2020/1523/P	98 Highgate West Hill N6 6NR	Amendments to proposed roof, dormer, side elevation window, side entrance and rear extension as granted by permission ref 2017/5939/P granted 18 December 2017 for erection of single storey lower ground floor rear extension, first floor rear part infill extension, rear and side dormer roof extensions; installation of four rooflights to the side roof slope; infill of first floor south side facing window and addition of first floor obscure glazed north side facing window	Thomas Sild
-------------	------------------------------------	--	-------------

Objection,

These comments update the earlier comments following the opening of the Non-Material Amendment Statement to public view on 11-Jun-20

Current view from very top of 97 attic window

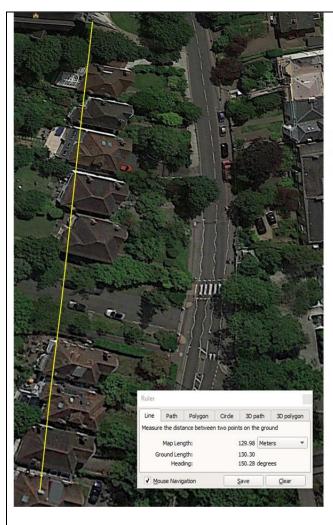
To match earlier view of church spire camera needs to be raised above the top of the attic window.

Using the 2 fixed points, the church tower & the window in 97, and conservatively estimating that 2m of the church tower is no longer visible from the original viewpoint then the ridge has been raised by c.125mm.

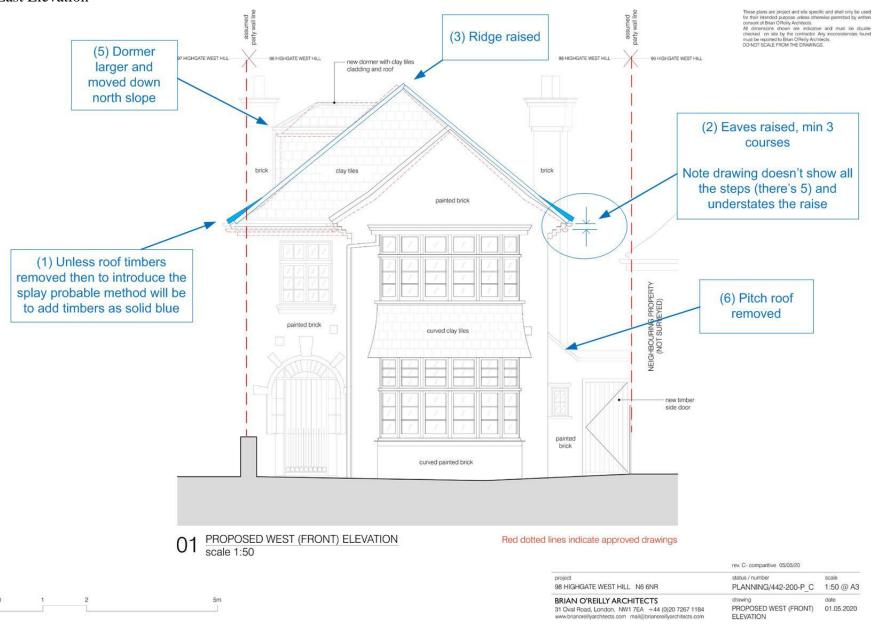
As stated above, it is good to see that the roof splays typical of Holly Lodge houses will be reinstated.

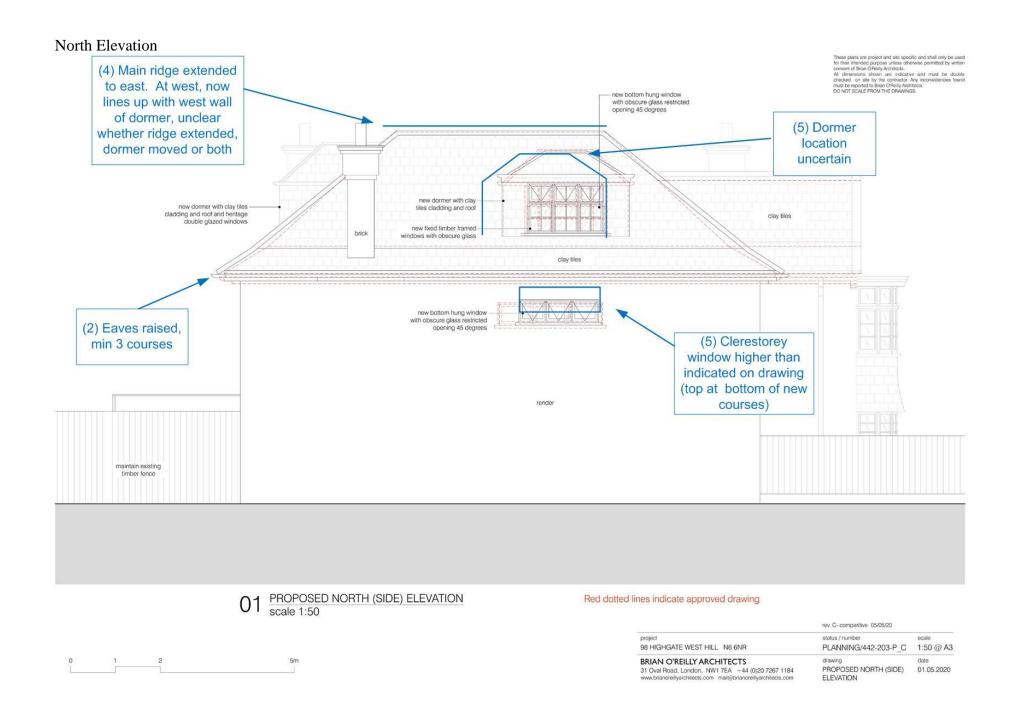
It would be better that the north dormer is correctly sized and in the correct position.

East Elevation

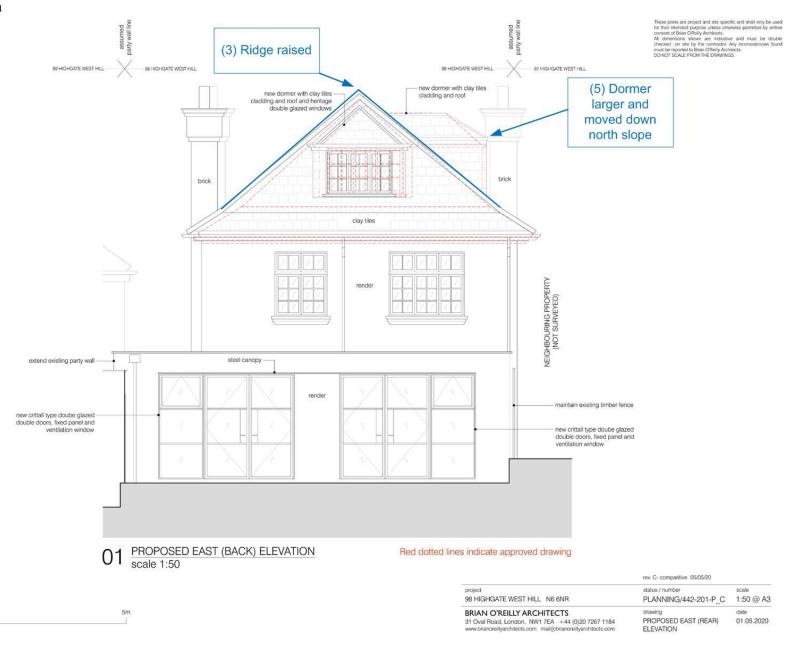
East
Drawings show ridge stopping well west of chimney, in fact it extends east – the yellow line follows a line of tiles

West Elevation

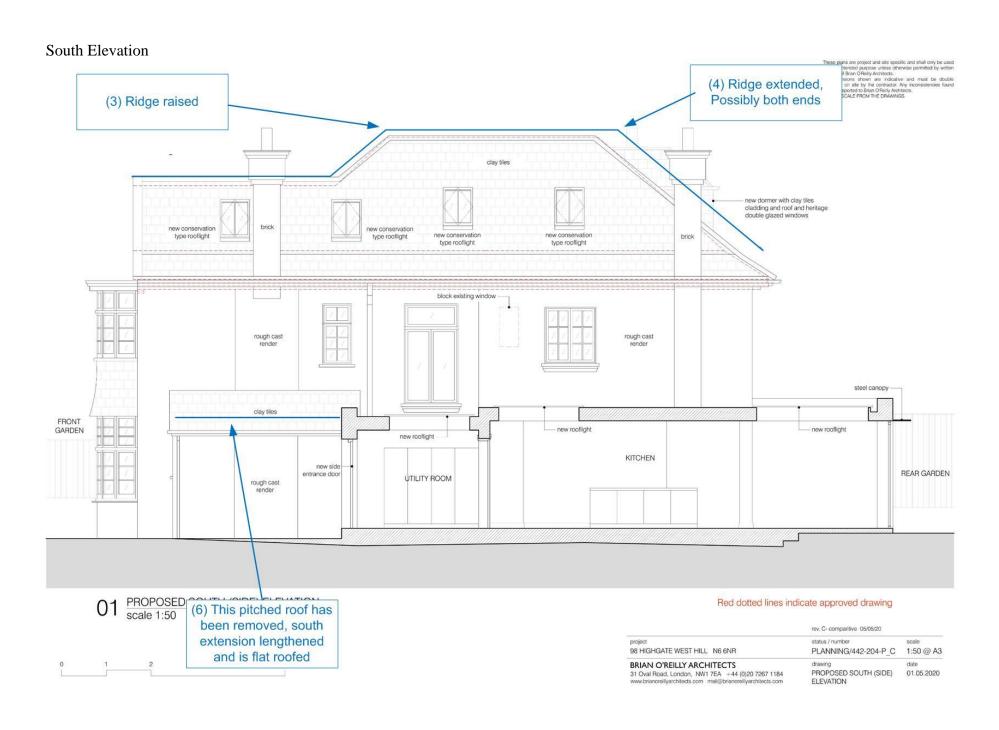
West Main roof ridge ends in line with west side of dormer, not stopping east as drawings show
